HISTORIC AND DESIGN REVIEW COMMISSION

September 02, 2026

HDRC CASE NO: 2026-218
ADDRESS: 245 W WILDWOOD
LEGAL DESCRIPTION: NCB 9013 BLK 7 LOT 69 70 AND 71
ZONING: R-4, H
CITY COUNCIL DIST.: 1
DISTRICT: Olmos Park Terrace Historic District
APPLICANT: Chelsea McGovern
OWNER: Chelsea McGovern/431320
TYPE OF WORK: Exterior Modifications, addition, porch enclosure
APPLICATION RECEIVED: August 03, 2026
60-DAY REVIEW: October 02, 2026
CASE MANAGER: Adrian Gallegos

The applicant is requesting conceptual approval to:

Remodel House Floor Plan

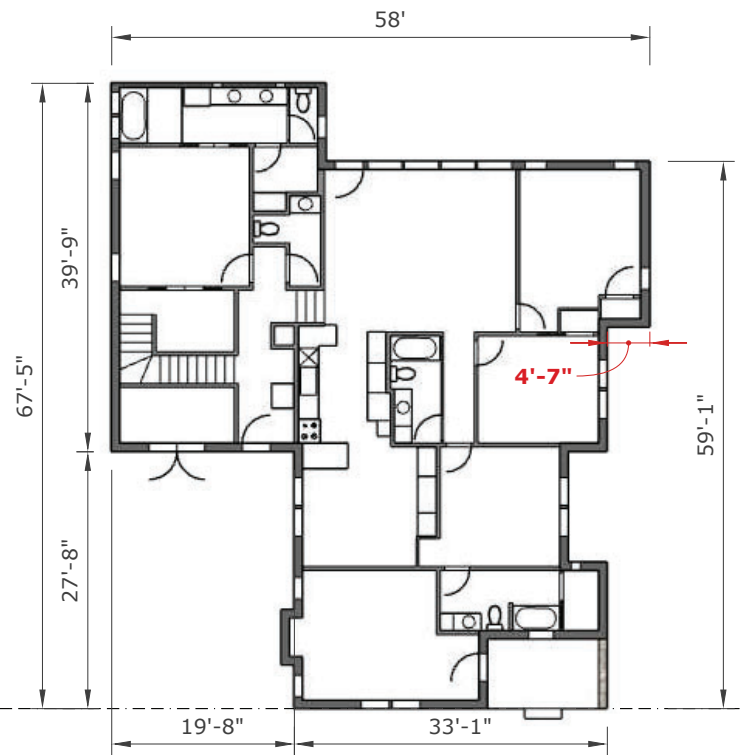
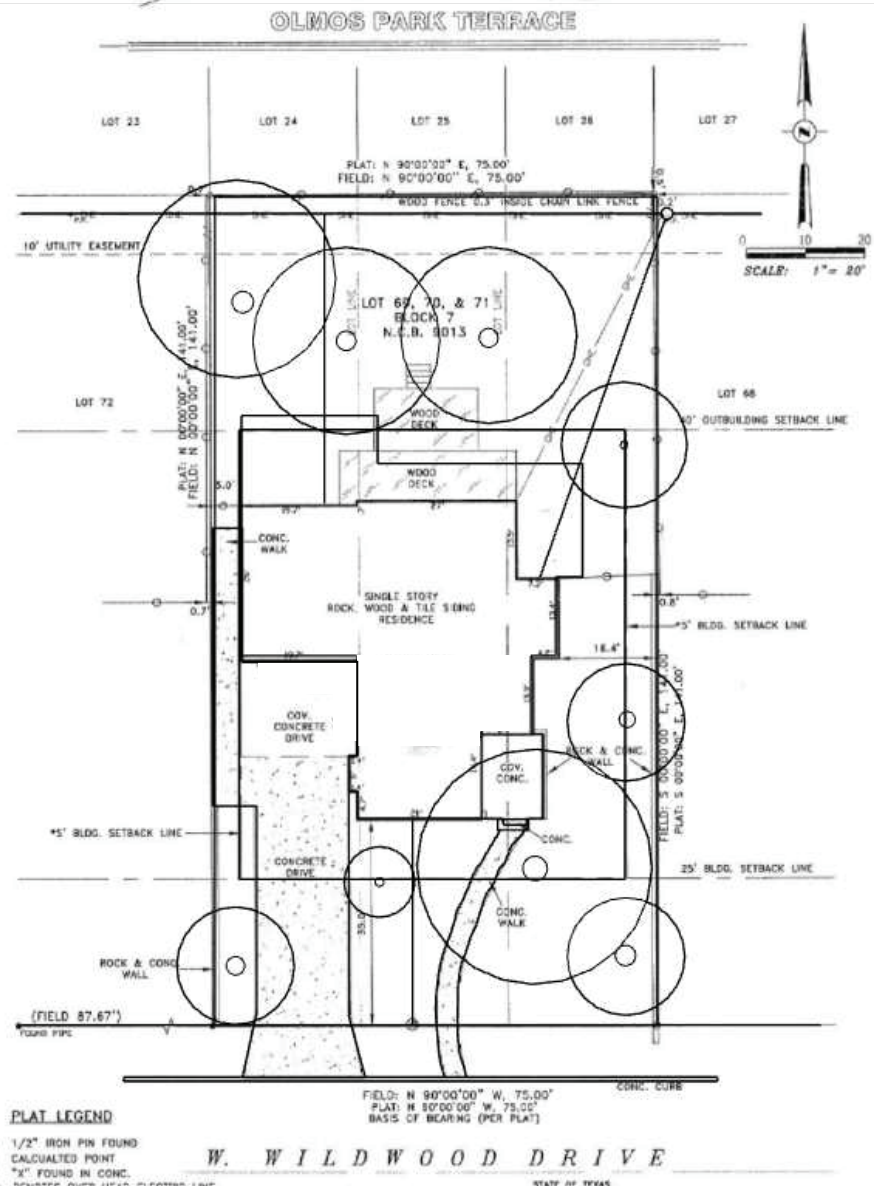
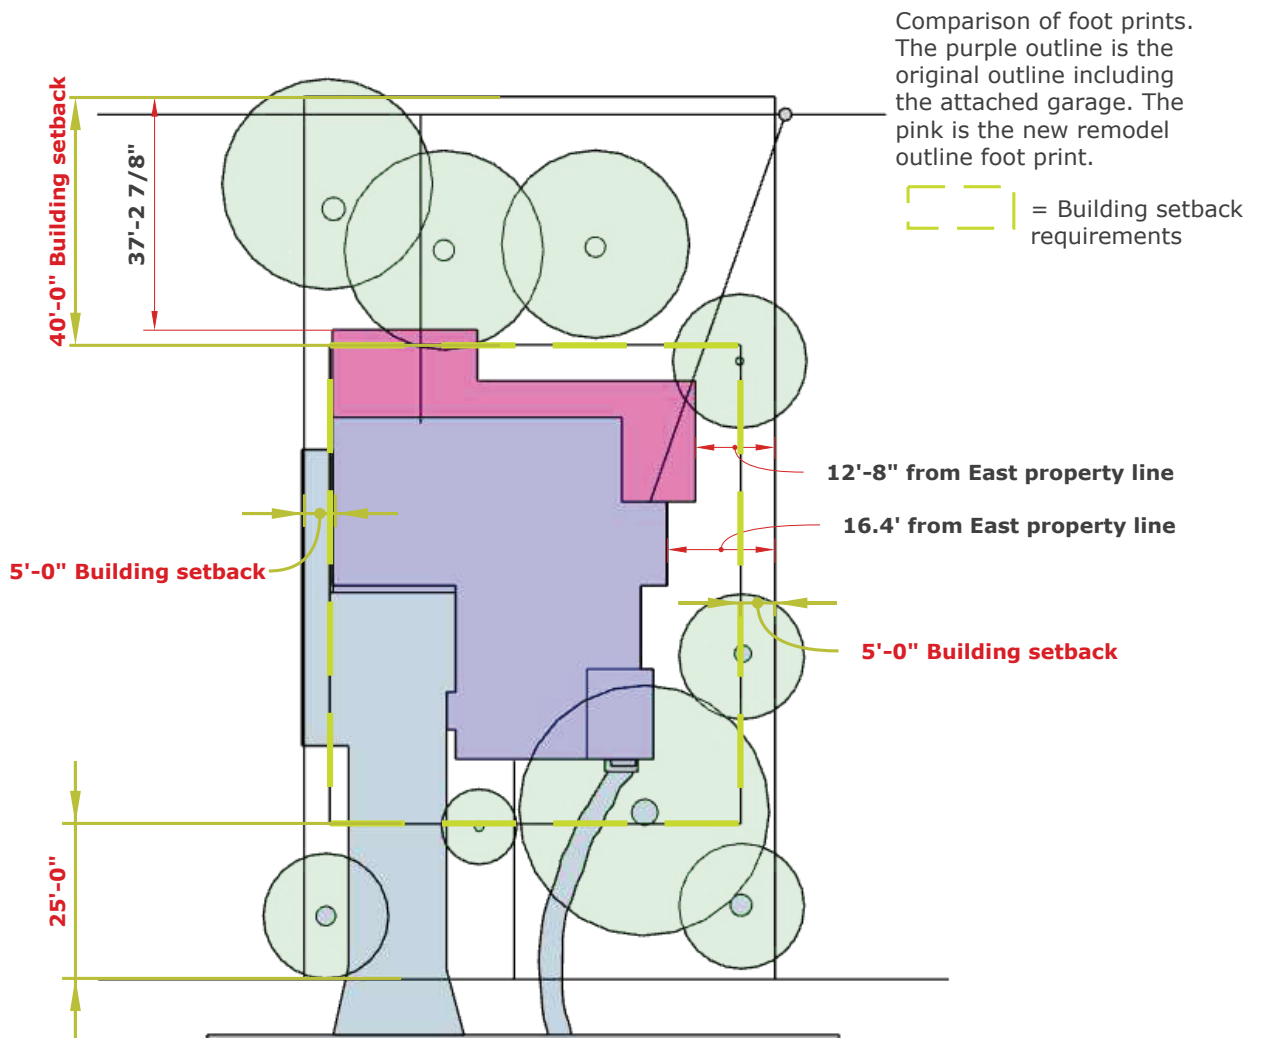
- c. ADDITION CONSTRUCTION (FOOTPRINT) – The applicant has proposed to construct an approximately 550 sf one and a half story rear addition to the existing approximately 1,731 sf historic structure onsite. Additions 1.B.iv states that the building footprint should respond to the size of the lot. An appropriate yard to building ratio should be maintained for consistency within historic districts. Residential additions should not be so large as to double the existing building footprint, regardless of lot size. The square footage of proposed rear addition is roughly 34 percent of the existing building footprint. Staff finds the footprint of the proposed rear addition to be consistent with the Guidelines.

- d. **ADDITION CONSTRUCTION (MASSING)** – The applicant has proposed to construct an approximately 550 sf one and a half story rear addition to the existing approximately 1,731 sf historic structure onsite. Guideline 1.A.i. for Additions states that residential additions should be sited at the rear of the building whenever possible to minimize views of the addition from the public right-of-way, an addition to the front of a building would be inappropriate. 1.A.ii. for Additions states that new residential additions should be designed to be in keeping with the existing, historic context of the block. Additions 1.B.i additionally stipulates that residential additions should be designed to be subordinate to the principal façade of the original structure in terms of scale and mass. Additions 1.B.v. states that generally, the height of new additions should be consistent with the height of the existing structure, the maximum height of new additions should be determined by examining the line-of-sight or visibility from the street, and the addition height should never be so contrasting as to overwhelm or distract from the existing structure. Staff finds the proposed addition massing generally appropriate.

Item 1 - Staff recommends conceptual approval of the request to construct a rear addition based on findings a through k with the following stipulations:

Remodeled view of house looking Southeast.

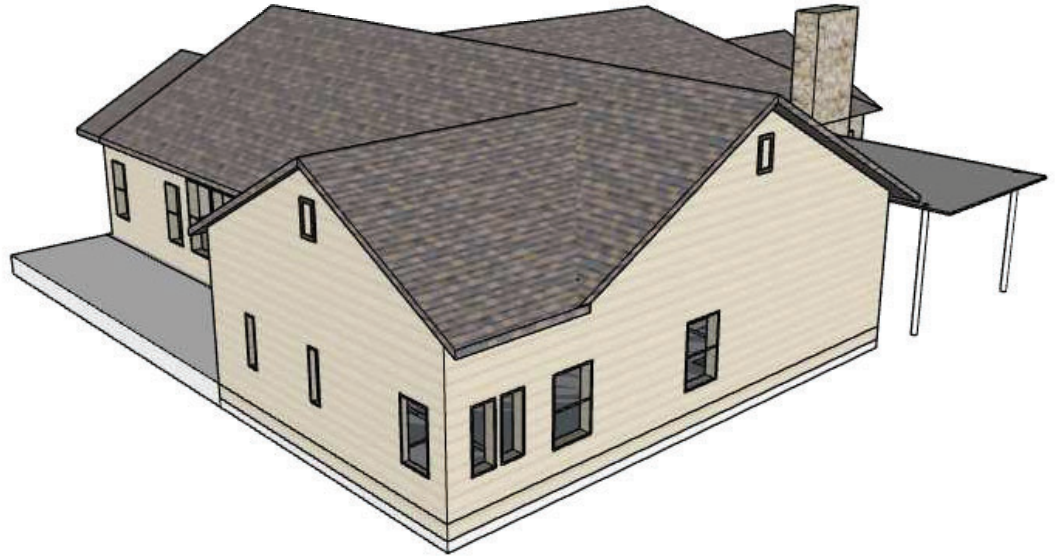
- j. **ADDITION: NEW WINDOWS: SIZE AND PROPORTION** – The proposed addition includes new window openings to the east, west, and north elevations. The elevation drawings for the proposed rear elevation include window openings that do not have traditional proportions and are not in keeping with the windows on the rest of the structure. The Standard Specifications for Windows in Additions and New Construction clarifies that new windows on additions should relate to the windows of the primary historic structure in terms of materiality and overall appearance. Staff finds the proposed fenestration pattern inconsistent and recommends window openings with traditional proportions.

- i. That the applicant modify the fenestration pattern on the north elevation of the proposed addition to include windows of traditional proportions as noted in finding j.

- ii. That the applicant submit dimensioned elevation drawings reflecting stipulation i has been met.
- iii. That the applicant submits final material specifications for wood or aluminum clad wood windows as noted in finding k. Windows should feature an inset of two (2) inches within facades and should feature profiles that are found historically within the immediate vicinity. An alternative window material may be proposed, provided that the window features meeting rails that are no taller than 1.25" and stiles no wider than 2.25". White manufacturer's color is not allowed, and color selection must be presented to staff. There should be a minimum of two inches in depth between the front face of the window trim and the front face of the top window sash. This must be accomplished by recessing the window sufficiently within the opening or with the installation of additional window trim to add thickness. Window trim must feature traditional dimensions and an architecturally appropriate sill detail. Window track components must be painted to match the window trim or be concealed by a wood window screen set within the opening.
